## FIRST & CEDAR APARTMENTS

Studio apartments for currently homeless individuals

Early Design Guidance

April 8, 2008

**CEDAR STREET ELEVATION**

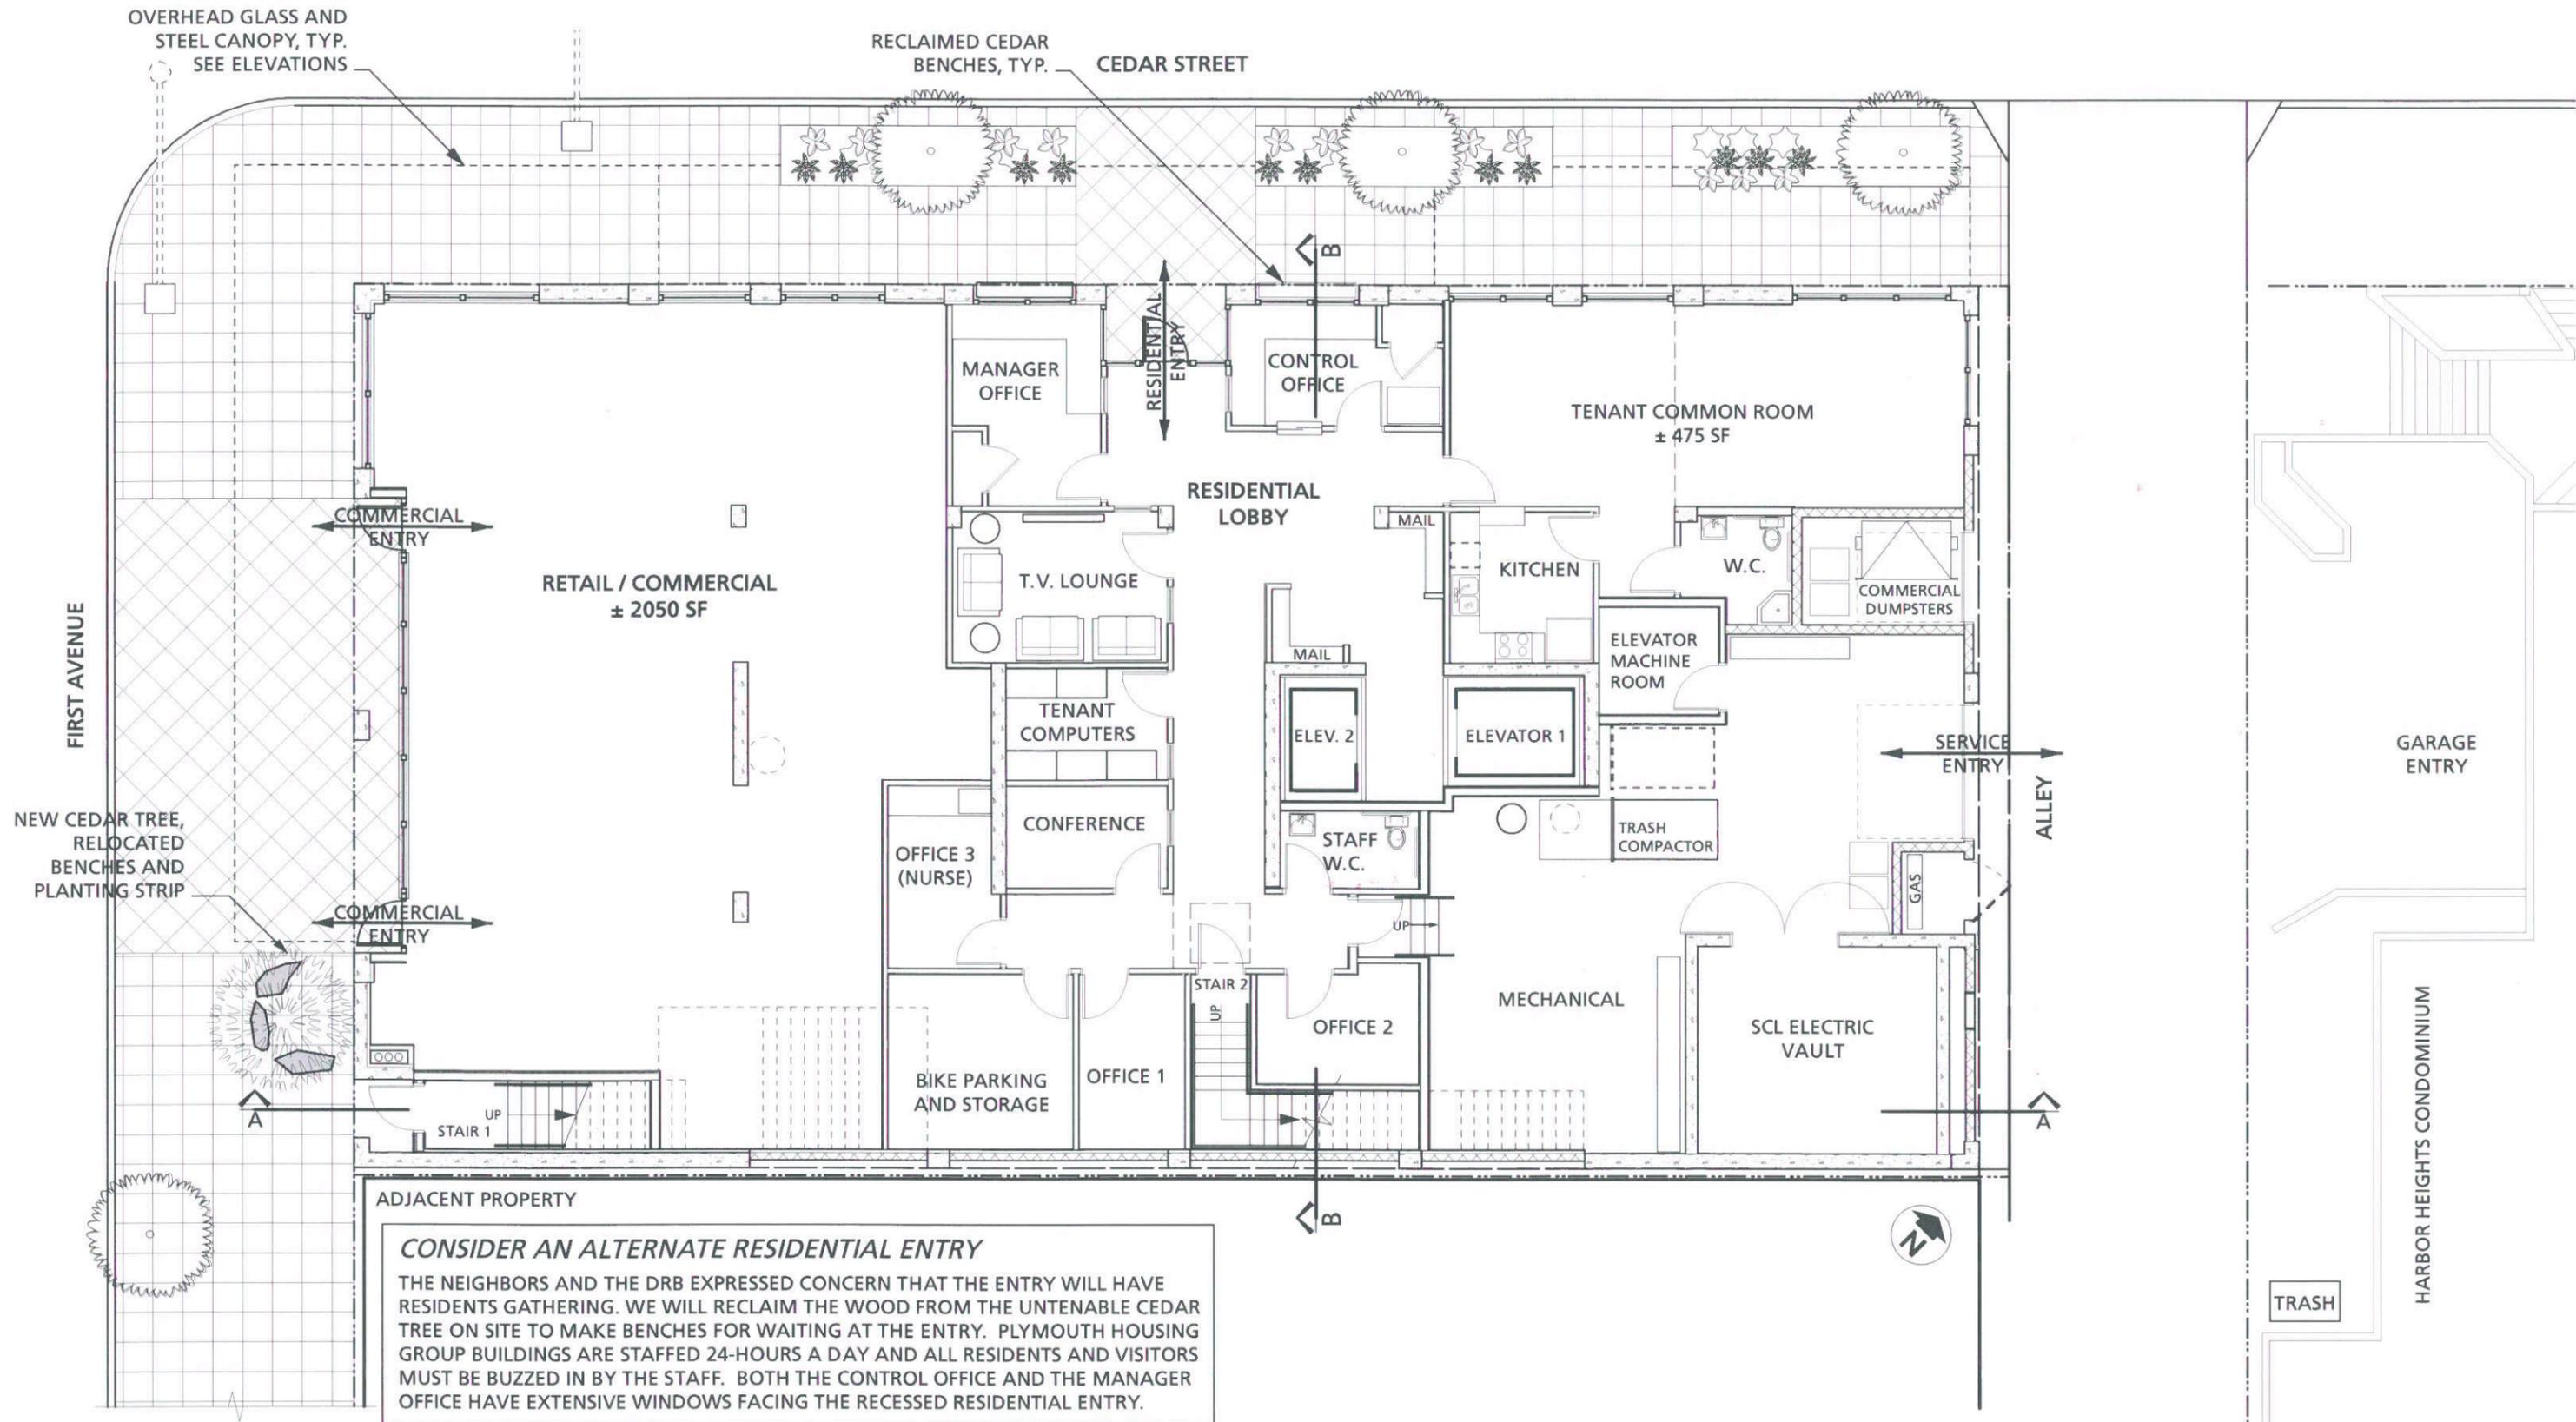
**CONSIDER AN ALTERNATE  
RESIDENTIAL ENTRY**

MOVING THE RESIDENTIAL  
ENTRY TO THE CENTER OF THE  
BUILDING CLEARLY  
ACCENTUATES THE ENTRY.  
FURTHERMORE, WE HAVE  
INTEGRATED BUILDING SIGNAGE  
ABOVE THE ENTRY AND  
INCREASED THE HEIGHT AND  
DEPTH OF THE CANOPY.

**CREATE A WELL-ORGANIZED ROOF**

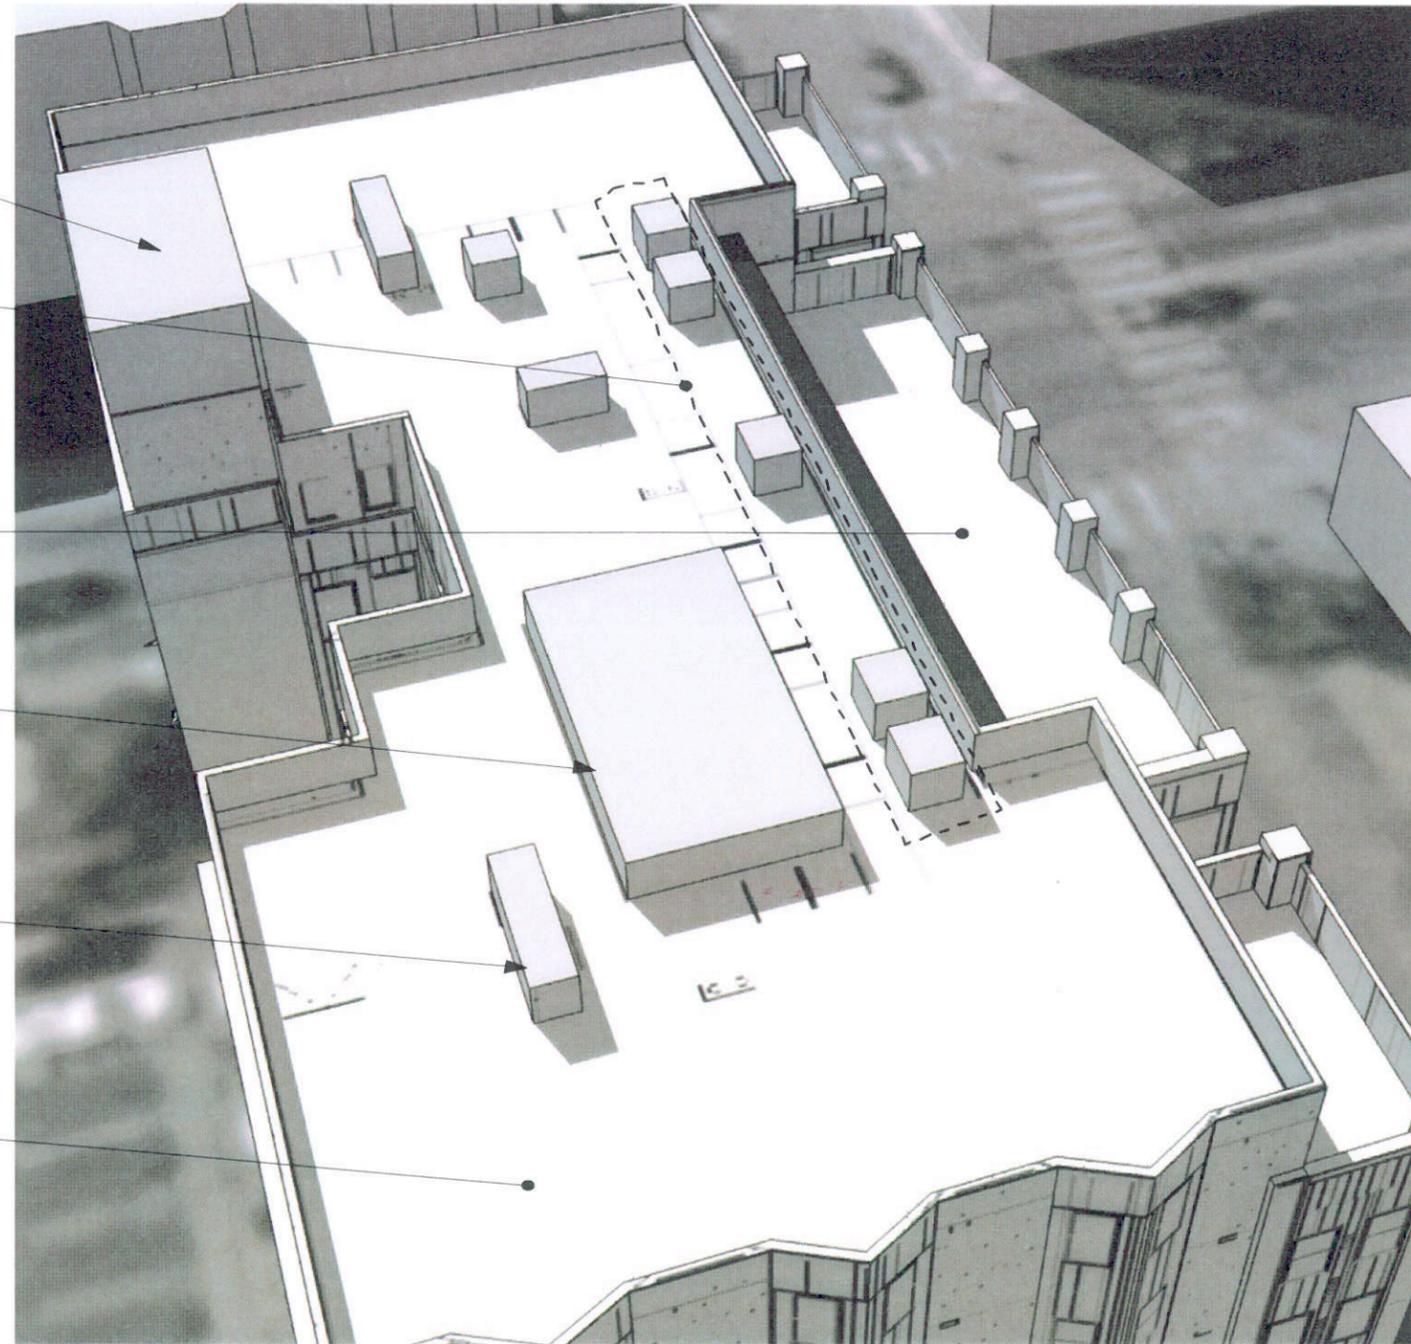
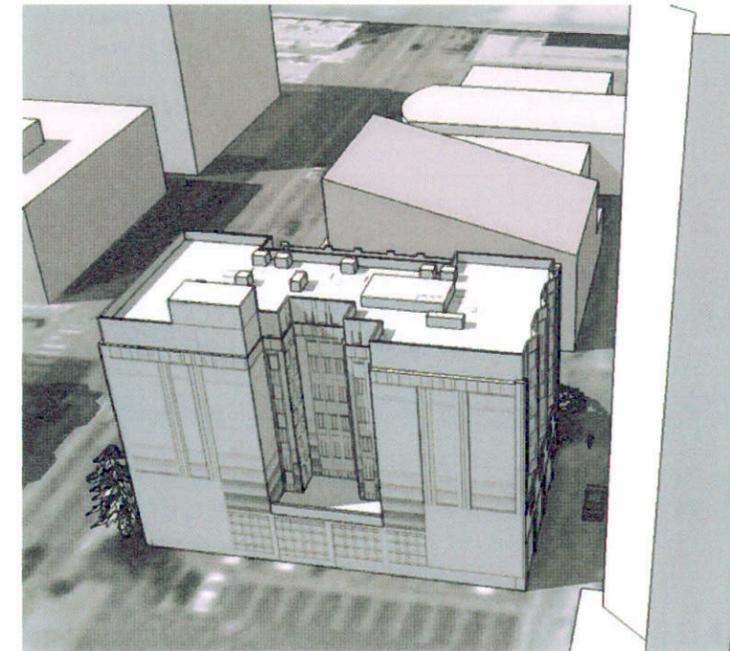
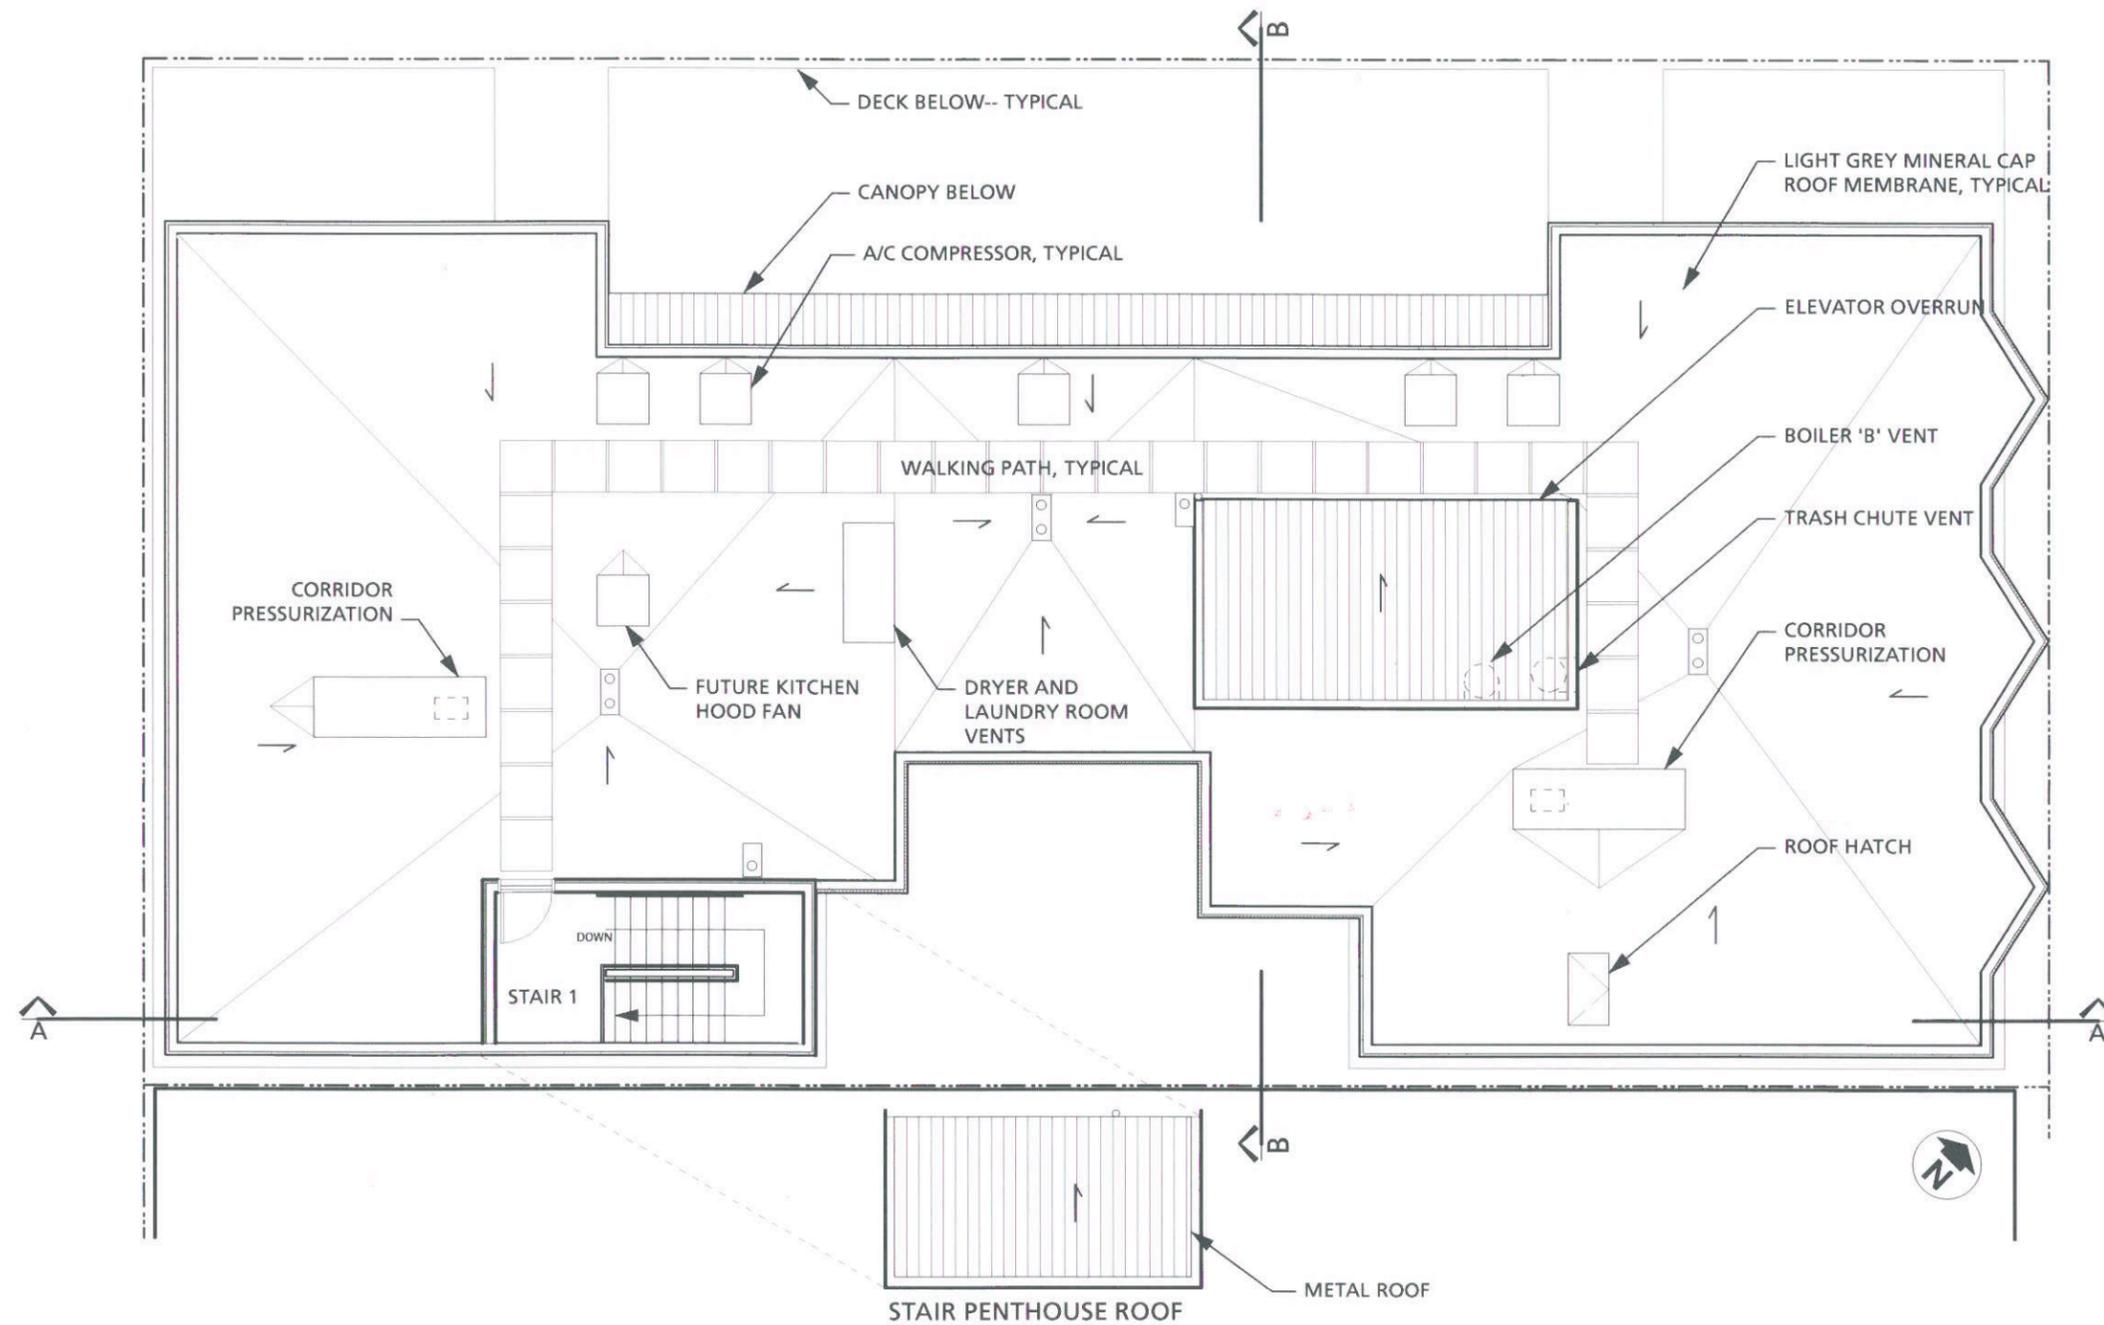
WE HAVE CREATED AN ORGANIZED AND ATTRACTIVE ROOF TOP DESIGN BECAUSE IT WILL BE VISIBLE FROM TALLER BUILDINGS. MECHANICAL EQUIPMENT HAS BEEN SIZED AND PLACED TO MINIMIZE THE OBTRUSIVENESS TO RESIDENTS ABOVE. ALL RANGEHOOD AND BATHROOM VENTILATION DISCHARGE LOCATIONS ARE PROPOSED TO BE ROUTED HORIZNTALLY-- ELIMINATING 30 SHEET-METAL HOODS AT THE ROOF SURFACE. A 42" HIGH PARAPET WILL HIDE ALL PROTRUSIONS EXCEPT FOR THE FIRE STAIR TO THE ROOF AND THE FOUR FOOT HIGH ELEVATOR PENTHOUSE (ELEVATOR DOES NOT EXTEND TO THE ROOF). THESE PROTRUSIONS WILL HAVE NON-REFLECTIVE METAL ROOFS. THE ROOF MEMBRANE ITSELF WILL BE OF A NON-REFLECTIVE GRAY COLOR. THE STAIR PENTHOUSE PALLET WILL BE OF A LIGHT, NEUTRAL COLOR, TO DOWNPLAY ITS VISUAL IMPACT.

STAIR TO ROOF LEVEL FOR FIREFIGHTING (NO PUBLIC OR TENANT ACCESS). WE CHOSE TO USE THE STAIR FARTHEST FROM ADJACENT BUILDINGS (I.E. HARBOR HEIGHTS). STUCCO FINISH WITH METAL ROOF.

AIR CONDITIONING CONDENSER UNITS-- AS CLOSE TO CEDAR STREET AS POSSIBLE.

ELEVATOR PENTHOUSE: 4'-0" ABOVE ROOF (THEREFORE 6" ABOVE PARAPET). STUCCO COLOR WITH METAL ROOF.

THERE ARE TWO CORRIDOR VENTILATION UNITS ON THE ROOF. BOTH ARE 7' LONG, 3' DEEP AND 3' TALL. THEIR LOCATION IS FIXED BY THE LOCATION OF CORRIDORS.

WE HAVE PLANNED THE ROOF AS A LIGHT GREY MEMBRANE ROOF, A TYPICAL ROOF FOR FLAT ROOFED BUILDINGS IN SEATTLE.
